To: Neil Harkin, Queenstown Lakes District Council
From: Anita Vanstone (Strategic Growth Manager), Catriona Lamont (Spatial Plan Project Manager) and Cameron Wood (Senior Strategic Planner), Strategic Growth Team, QLDC
Date: 28 October 2025
Subject: Summary of the Te Tapuae Southern Corridor Structure Plan and assessment against the Fast Track Resource Consent for Homestead Bay, and Affordable Housing.

Part 2: Comparative assessment of the TTSC Structure Plan and the Homestead Bay Fast Track Resource Consent

Table 2: Comparison between RCL and Te Tapuae Southern Corridor Structure Plan

Assessed Liquefaction Vulnerability

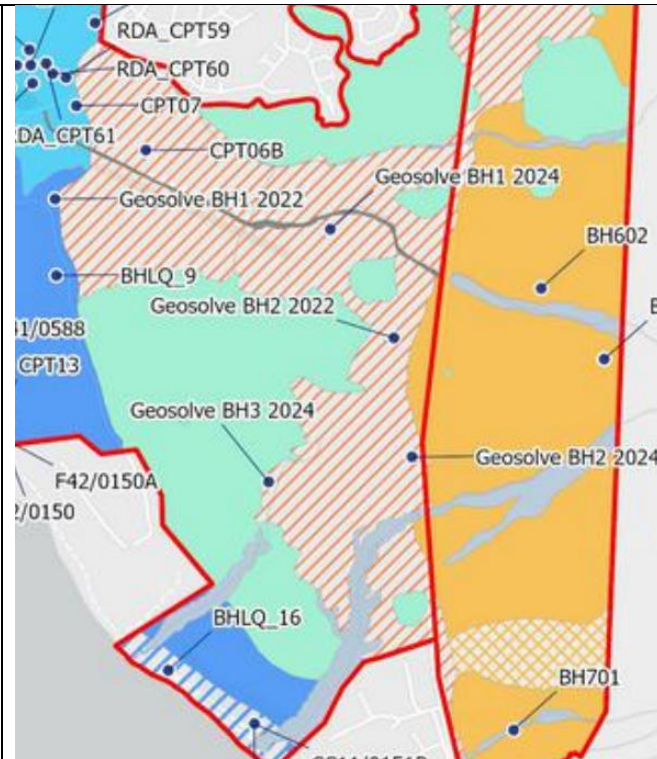
<i>Natural Hazards</i>			
Natural Hazards	The supporting technical evaluation for the TTSC Structure Plan included a natural hazard assessment undertaken in accordance with ORC proposed Regional Policy Statement (RPS) 2021, Appendix 6. This included an assessment on liquefaction. <u>Liquefaction</u> Access to Lot 12 and Lot 8 to undertake site specific geotech investigations for the liquefaction assessment was not granted by RCL and therefore, limited investigations were undertaken on these lots in the Structure Plan assessment of natural hazards. The Structure Plan acknowledges that further work will be required to confirm the suitability of this land. The assessment level of detail and the assigned liquefaction susceptibility is also shown below as defined by MBIE. The assessment level of detail for the development is: <i>A- Basic Desktop Assessment</i> and <i>B Calibrated Desktop Assessment</i>. The below is extracted from the TTSC Liquefaction report, where Holocene alluvium is shown to be present in both Lot 8 and 12 (as per the 3rd image below). <i>“The lower portion of the alluvial fan/ area of Holocene alluvium near the eastern extent of the QLDC sports field is shown to have a ‘Moderate Liquefaction Vulnerability’. Only one investigation is available for this area and no additional</i>	<u>Liquefaction</u> Liquefaction assessment on Lot 12 is not provided as part of the technical assessments supporting the fast track application. The Applicant’s liquefaction assessment for Lot 8 focused on areas where there was perched ground water, being the eastern areas towards the SH6 where the groundwater (GW) level was between 2 and 6m deep. The remainder of the site does not have a perched groundwater level and the regional groundwater levels have been measured to be at least 10 to 15m depth. Only the CPTs in the upper platform where shallow groundwater is present were analysed as part of the liquefaction assessment. The site has been divided into two zones, the upper terrace where there is a perched groundwater table, and the remainder of the site where there is no perched groundwater table and a minimum non-liquefiable crust of 10 m is expected. This is where the social infrastructure identified in the Structure Plan could be re-located in to this area. The borehole closest to this area is: BH1-22. The groundwater in this bore was monitored:	TBC – waiting on further site specific investigations <u>Lot 12:</u> Assessment undertaken for structure plan is based on limited site specific investigations as permission was not granted to the land. No liquefaction assessment provided by RCL. <u>Lot 8:</u> Assessment undertaken for structure plan is

investigations were able to be undertaken due to land access restrictions. As such, there is insufficient information to constrain where, or if the liquefaction vulnerability uniformly decreases from ‘High’ to ‘Medium’ from the adjacent lake deposits. The area is therefore assigned as ‘Liquefaction Damage is Possible’. The transition from the lake deposits to the alluvial fan/ Holocene alluvium deposits has additionally been inferred from topography. Further geotechnical investigations would be required to refine the position of this transition, and additional investigations would be required to assign ‘Medium’ or ‘High Liquefaction Vulnerability’ to this area.”

Further assessment, including site specific investigations, is therefore required to confirm the liquefaction category. This is of particular importance to QLDC as the future location of the social infrastructure in the area that is confirmed as “liquefaction is possible”. As such the Structure Plan included an option where the area zoned as social infrastructure could be moved further south, into Lot 12, currently where high density is shown (in both the Structure Plan and the RCL scheme plan). The social infrastructure will still be close to the town centre and the existing sports field. In this instance the high density in the Structure Plan is shown to be relocated to Lot 8, this can only occur if there is no wastewater disposal on the lot.

based on limited site specific investigations as permission was not granted to the land. The level of detail in both assessments varies and a direct comparison is not possible.

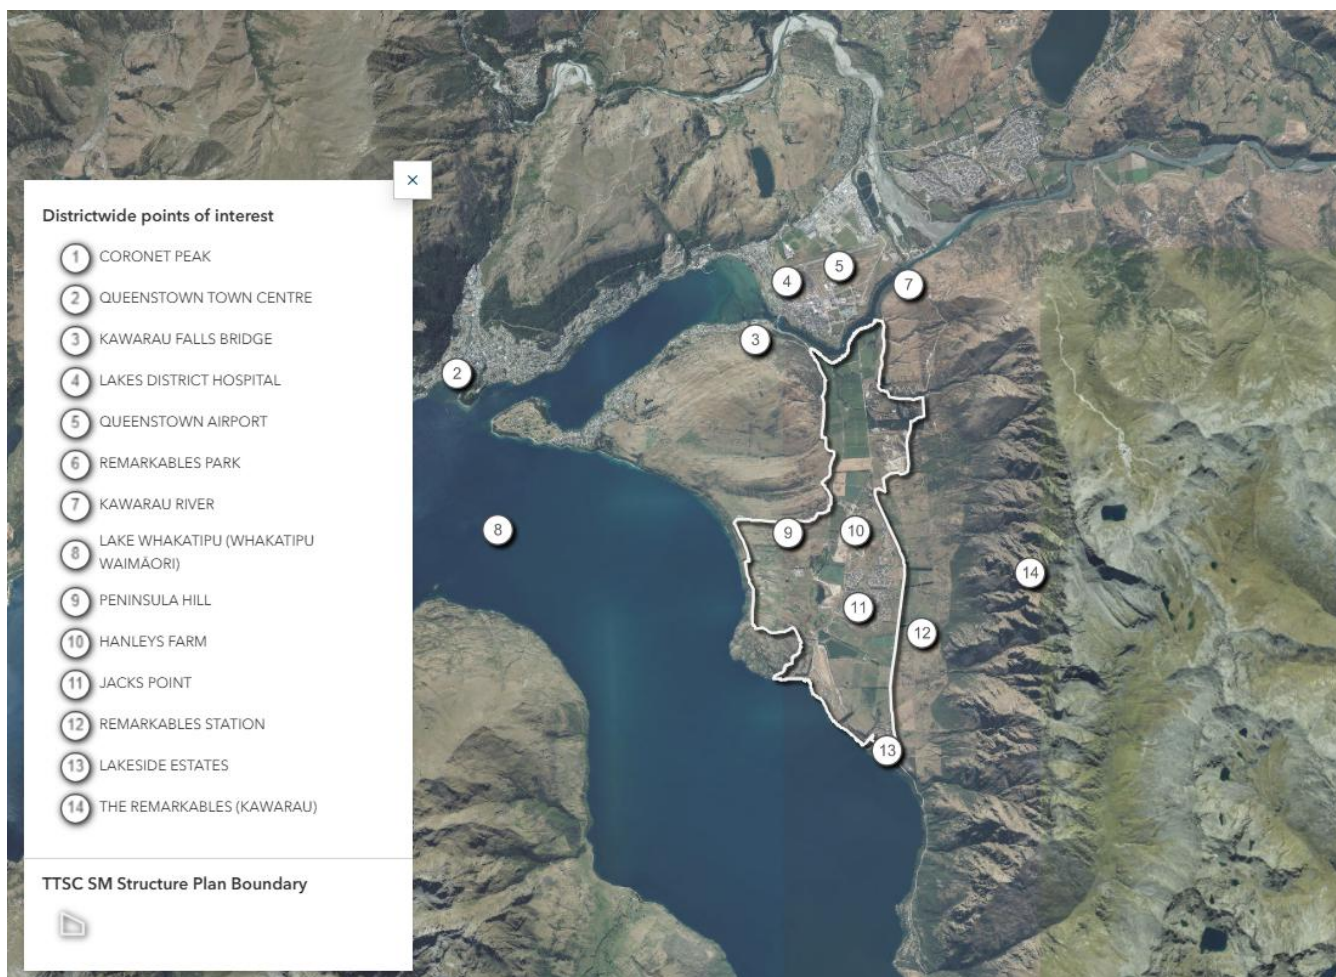
44. For reasons outlined above, the proposal will result in more housing choice but is unlikely to result in the provision of affordable housing. Perpetual affordable housing could be achieved through the following conditions:

X. At each stage of the subdivision the consent holder shall clearly identify the method for contributing to affordable housing, either in the form of land, money or a combination of both, that equates to 5% of the number of lots commensurate of the stage that is being developed. Where land is proposed, the land area shall be clearly defined in the scheme plan for that stage

47. Prior to certification pursuant to section 224(c) of the Resource Management Act 1991, the consent holder shall complete the following works as applicable to each stage of the subdivision:

yy An affordable housing contribution in the form of land, money, or a combination of both, that equates to 5% of the number of lots commensurate of the stage that is being developed shall be transferred to the Queenstown Lakes Community Housing Trust.
